Permit of Authorization to Construct an On-Site Sewage Facility Permit Valid For One Year From Date Issued

Permit Number: 116837
Issued This Date: 11/17/2023
This permit is hereby given to: Jesus Prieto Flores

**AEROBIC TREATMENT
DRIP TUBING SYSTEM**
DESIGNED FOR: JESUS PRIETO FLORES
1267 WESTERN SKIES DR.
SPRING BRANCH TX 78070

From: Thalia Rivas <rs.tr@ossfdesigns.com>
Sent: Sunday, February 4, 2024 9:15 PM
To: Olvera, Brandon <Olverb@co.comal.tx.us>; Ritzen, Brenda <rabbjr@co.comal.tx.us>
Subject: REVISIONS PERMIT 116837 ADDRESS: 1267 WESTERN SKIES DR.

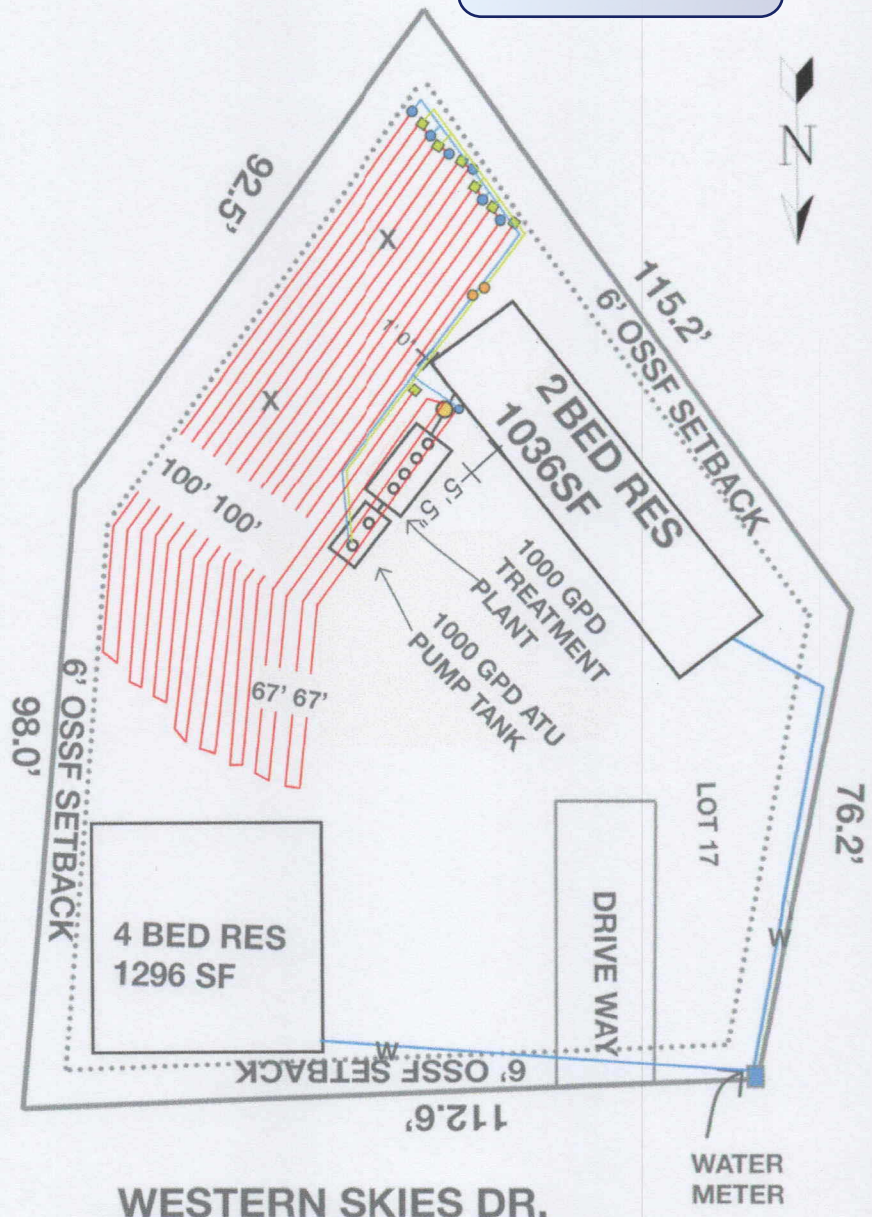
Your revision must be signed. Also, the 2nd page of the permit application has a typo on the amount of application area (attached). ✓

The attached page must also be updated to match your revised design.

INSTALL 2936SF OF FIELD TUBING USING 1468LNFT OF DRIP TUBING. THERE SHALL BE NO PARKING, DRIVING, OR STORAGE ON THE SEPTIC FIELD AT ANY TIME FOR ANY REASON.

INSTALL:
12 ROWS @ 100' EACH
4 ROWS @ 67' EACH
1468' OF DRIP TUBING
SPACED 2' APART

Pump Tank Requirements

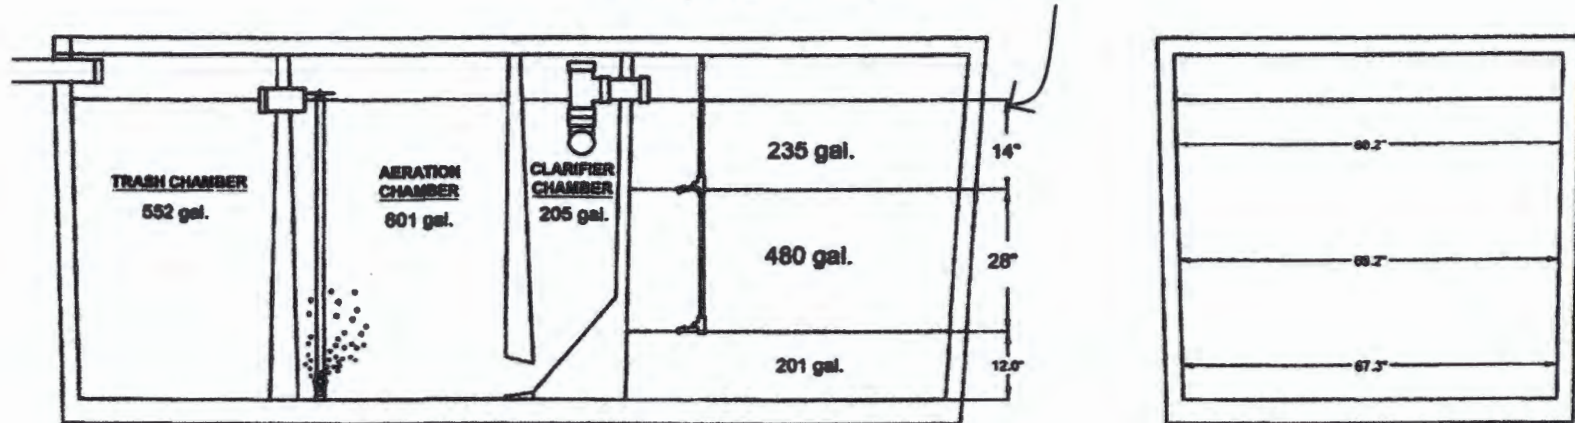
- ✓ The 2 year initial maintenance contract must be signed by both the owner and the maintenance provider.
- ✓ Submit a pump tank detail which identifies the location and height of all pump tank settings and identifies the minimum reserve capacity provided.
- ✓ A preliminary inspection has been scheduled for tomorrow. Once complete additional comments may be necessary.
- 4. Revise as needed and resubmit.
